ADDENDUM NUMBER 1

MILWAUKEE COUNTY COURTHOUSE
COOLING TOWER REPLACEMENT

Project Number: C102-14430

Date of Addendum: August 28, 2014

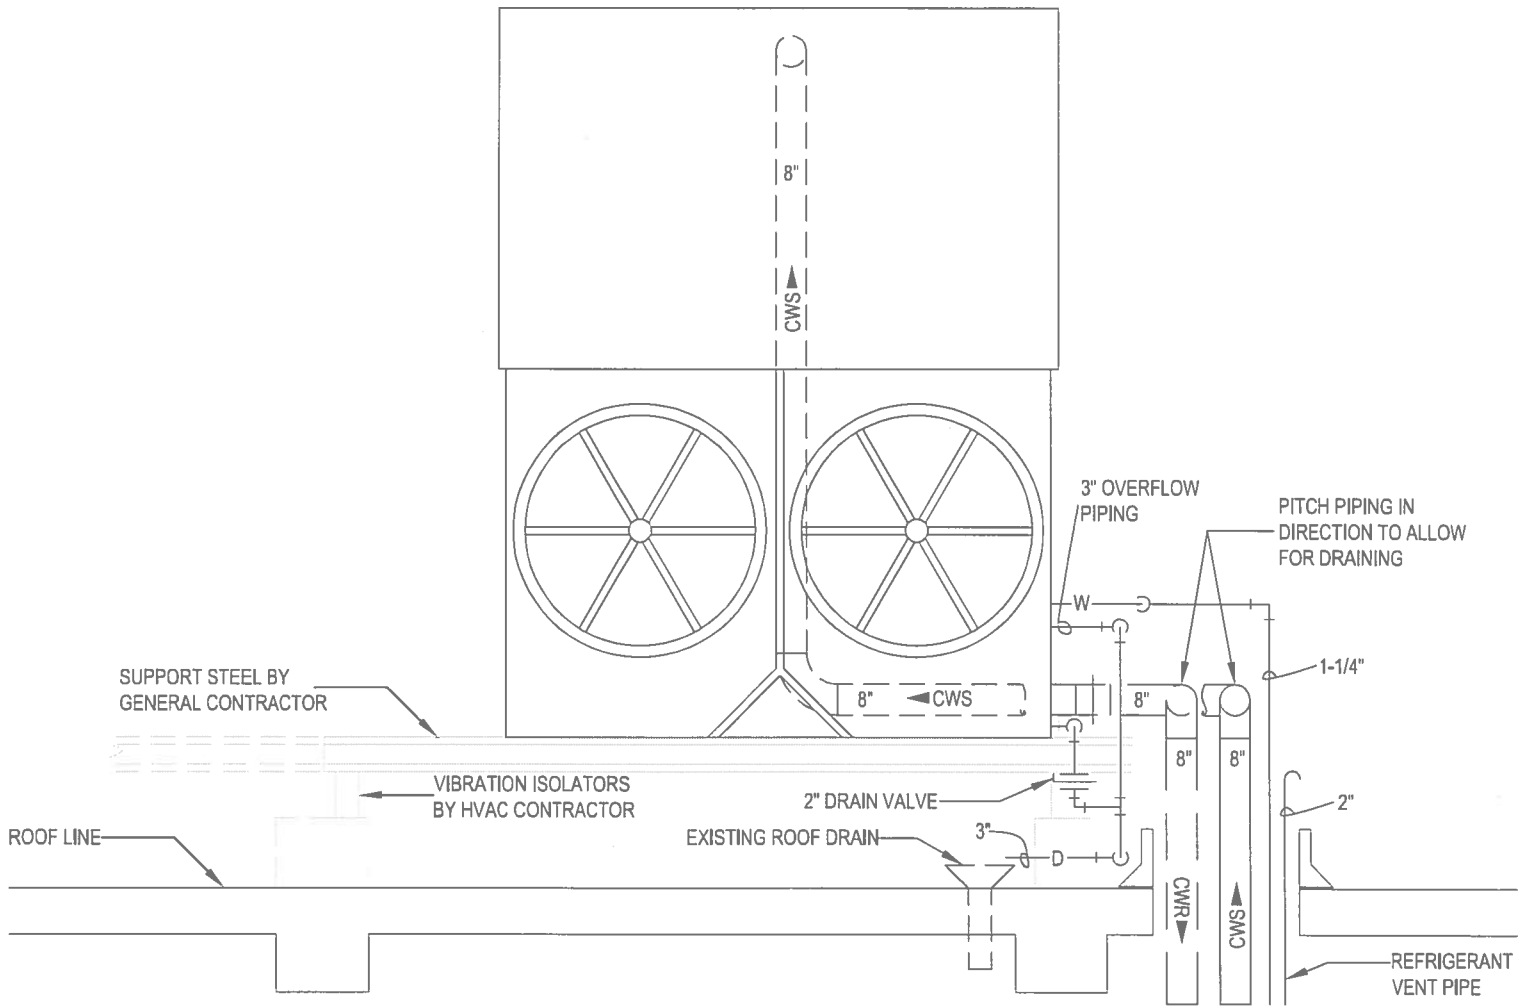
DELETE Section 26 00 00 Electrical Specifications and refer to the book specifications.
DELETE Cooling Tower Schedule and insert in its place Attachment drawing M001A.
INSERT the following new Note to M001: "CONTRACTOR SHALL BE RESPONSIBLE FOR SECURING PERMITS FROM THE CITY OF MILWAUKEE TO SHUT DOWN STREETS AND LIFT ALL EQUIPMENT INTO PLACE."

3 SECTION "B-B"
1/4" = 1' - 0"

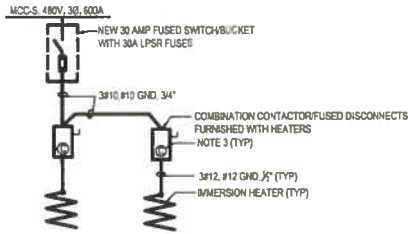
INSERT Section Detail 3 , SECTION B-B from Attachment drawing M002A
INSERT a new note on M002 as follows: "A STAINLESS STEEL CAP OVER THE TOP FLANGE OF STEEL SUPPORT WILL BE ACCEPTABLE IN LIEU OF PAINTING THAT PART OF THE FRAME."

5 IMMERSION HEATER WIRING DIAGRAM (ALTERNATE BID)

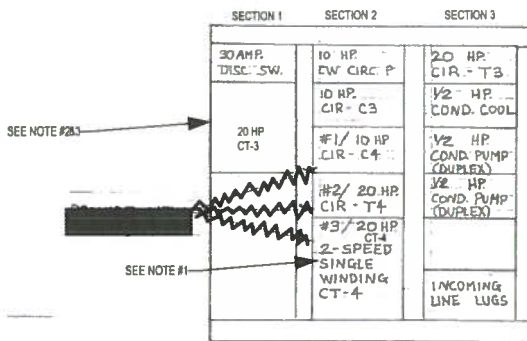
INSERT Details 2, 3, 4 & 5 from Attachment drawing ME003A
INSERT a new note on ME003 as follows: "A STAINLESS STEEL CAP OVER THE TOP FLANGE OF STEEL SUPPORT WILL BE ACCEPTABLE IN LIEU OF PAINTING THAT PART OF THE FRAME."

1. PROVIDE A SEALTITE FLEX CONNECTION TO ALL TOWER MOUNTED EQUIPMENT.
2. NEW ROOF PENETRATIONS SHALL BE PROPERLY SEALED.
 - a. IN BUILT UP ROOFING (BUR), PROVIDE ALL CURBS, CANTS AND BASE FLASHING.
 - b. IN ELASTIC SHEET ROOFING (ESR), ARRANGE AND PAY FOR FLASHING WORK BY AUTHORIZE ROOFER.
3. EACH HEATER COIL TO BE CONTROLLED BY A LOWER WATER SWITCH, THERMOSTAT AND A LOCAL SWITCH DISCONNECT ALL WIRED IN SERIES. PROVIDE AND INSTALL FUSE, CONTROL, TRANSFORMER, TOGGLE SWITCH, AND ALL CONTROL WIRING FOR HEATER CONTROL AS REQUIRED IN HEATER INSTALLATION GUIDELINES. COORDINATE CONTROL TRANSFORMER VOLTAGE WITH CONTACTOR COIL VOLTAGE.
4. CONTROL TRANSFORMERS TO BE 480 VOLT PRIMARY AND TAPPED FROM LINE SIDE OF CONTACTORS.
